Project: SE Polk CSD Four Mile Elementary Lighting Replacement Project Number: 25-175 Date: March 26, 2026

Note { *This addendum has been issued to modify and/or interpret the bidding documents, including the drawings and specifications. Unless otherwise instructed, the information contained on the addendum shall take precedence over anything contrary on the original bidding documents and shall be hereinafter considered as a part of the bidding documents.*

VERSION	100% CONSTRUCTION DOCUMENTS
DATE	03/28/2008
SHEET NAME:	DEMOLITION PLAN - AREA C
SHEET:	ED1.3

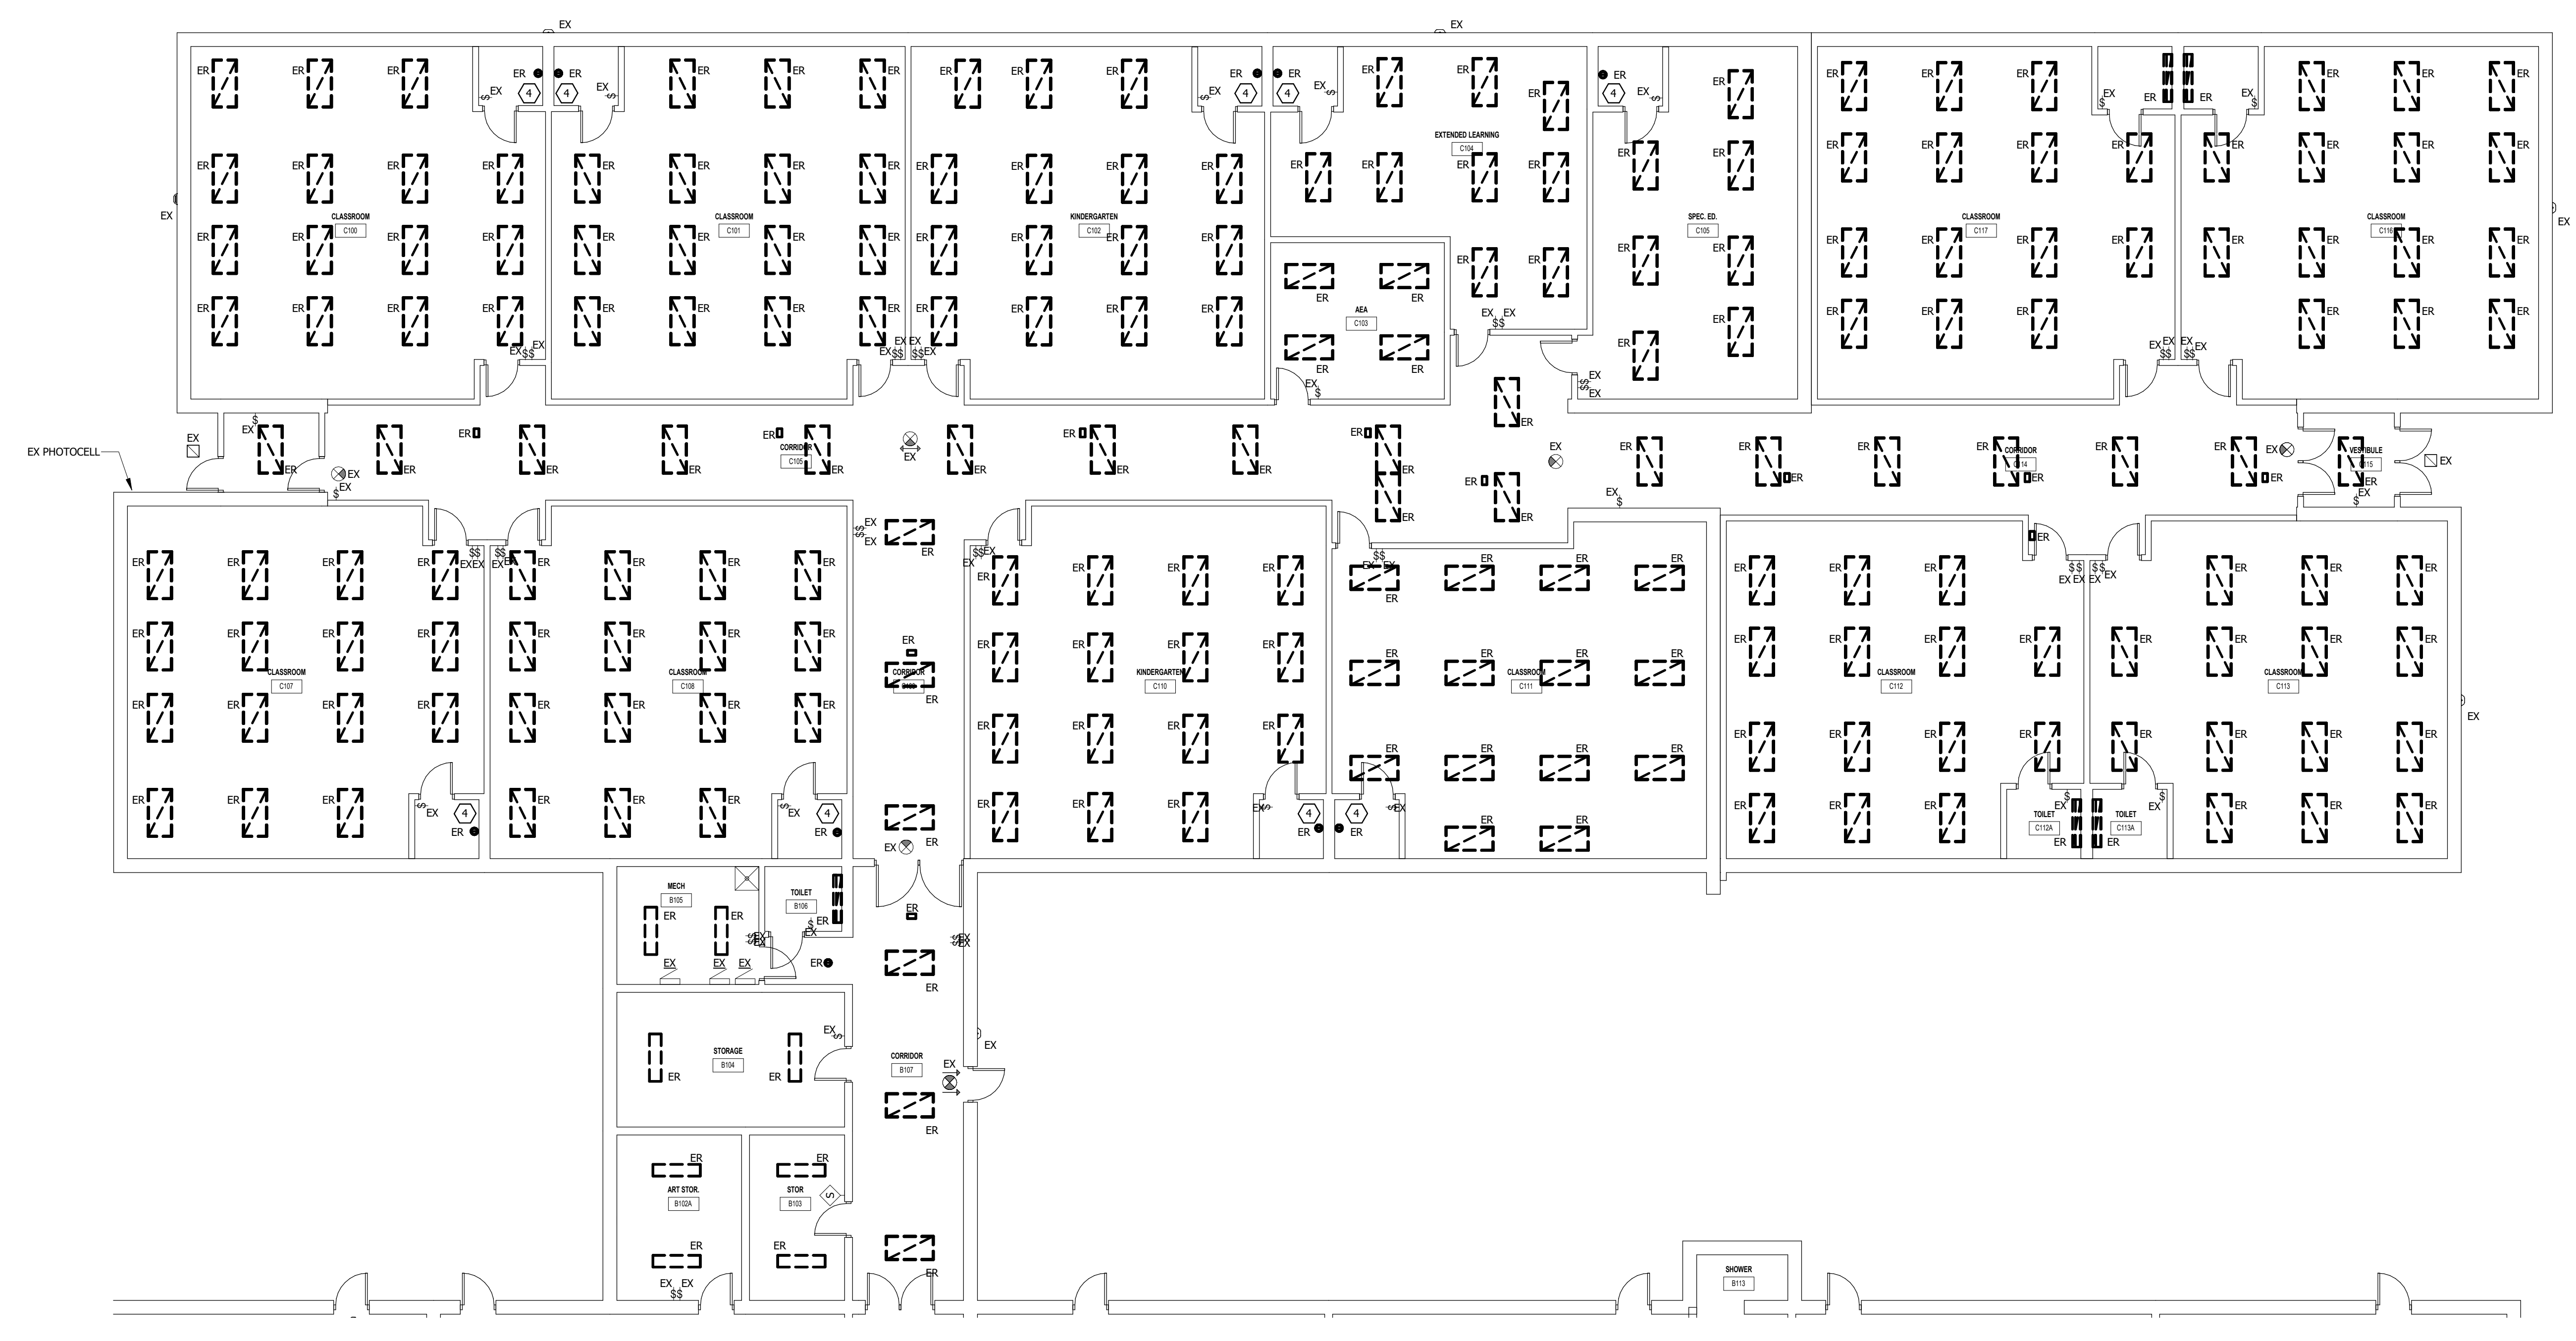
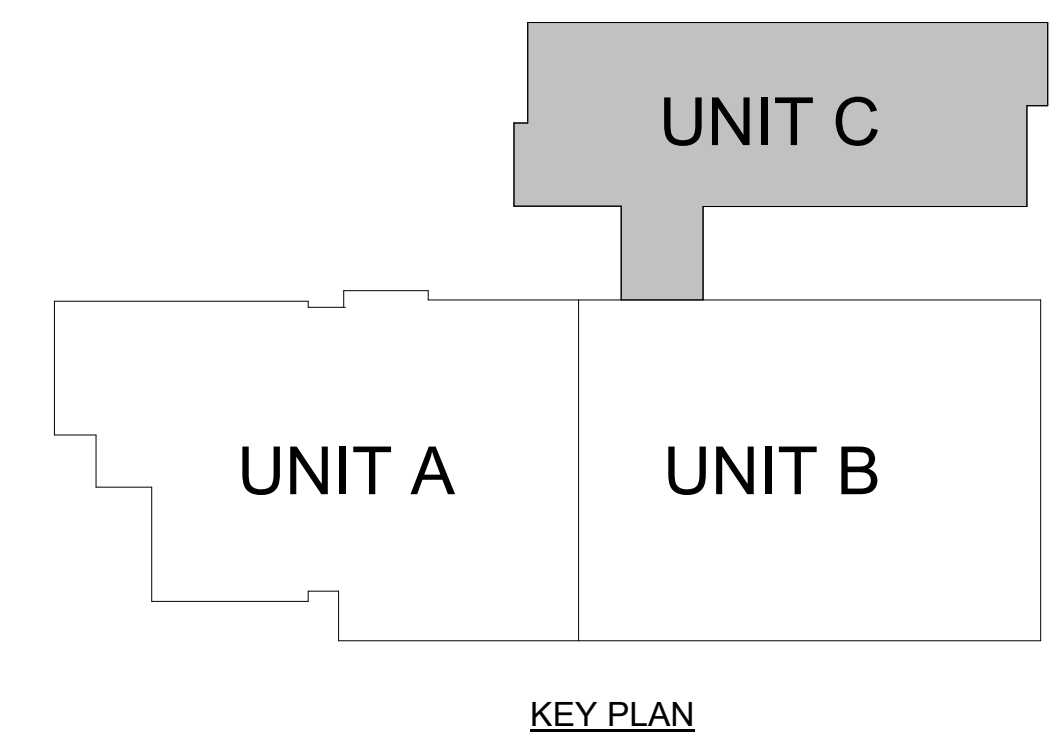
1. **REVISE** bolded scope note to include fixture type PC-X under alternate scope.

VERSION	100% CONSTRUCTION DOCUMENTS
DATE	03.28.2008
SHEET NAME:	LIGHTING PLAN - AREA A
SHEET:	E1.1

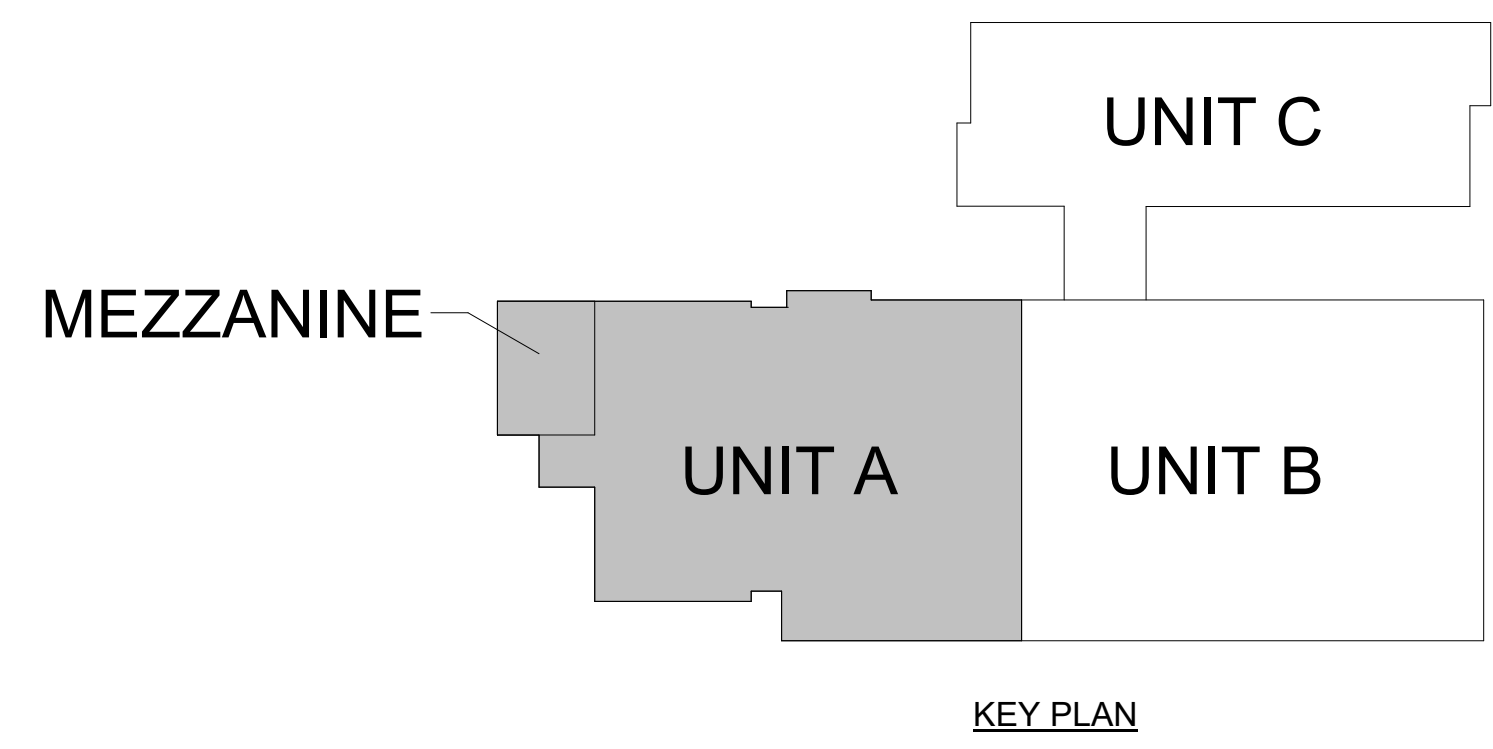
1. **REVISE** existing switches to be occupancy sensor wall switches as shown on the attached sheet.
2. **REVISE** orientation of new RA 2x4 troffer in nurse’s office as shown on the attached sheet.
3. **REVISE** bolded scope note to include fixture type PC-X under alternate scope.
4. **ADD** general notes J and K as shown on the attached sheet.

3 LIGHTING CONTROLS WIRING DIAGRAM  
No Scale

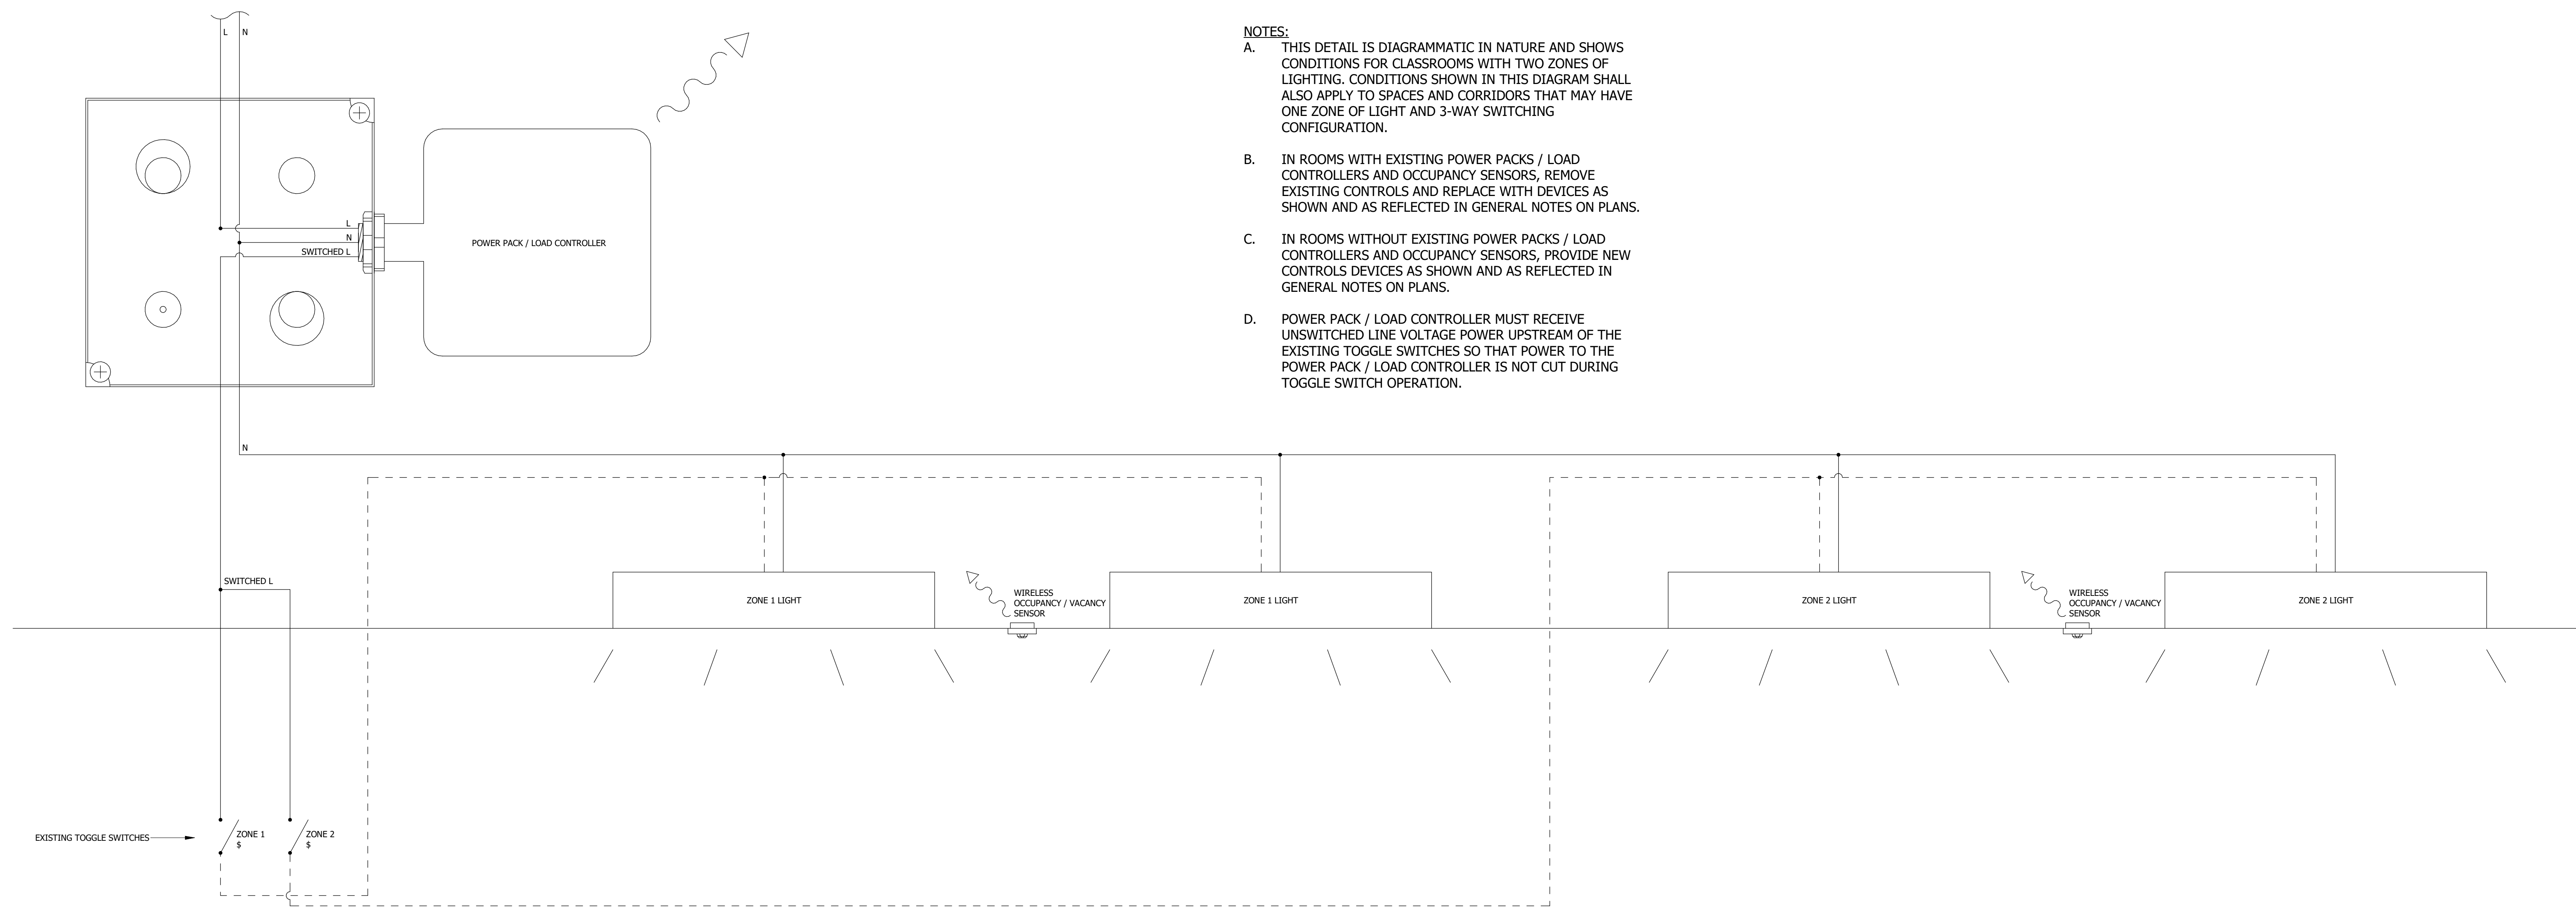
1. Lighting Fixture Schedule
  1. **ADD** approved equals on the lighting fixture schedule.
  2. **ADD** type PC-X as shown on the attached sheet.
  3. **REVISE** type RB to 3500K CCT.
2. **ADD** Lighting Controls Wiring Diagram detail.
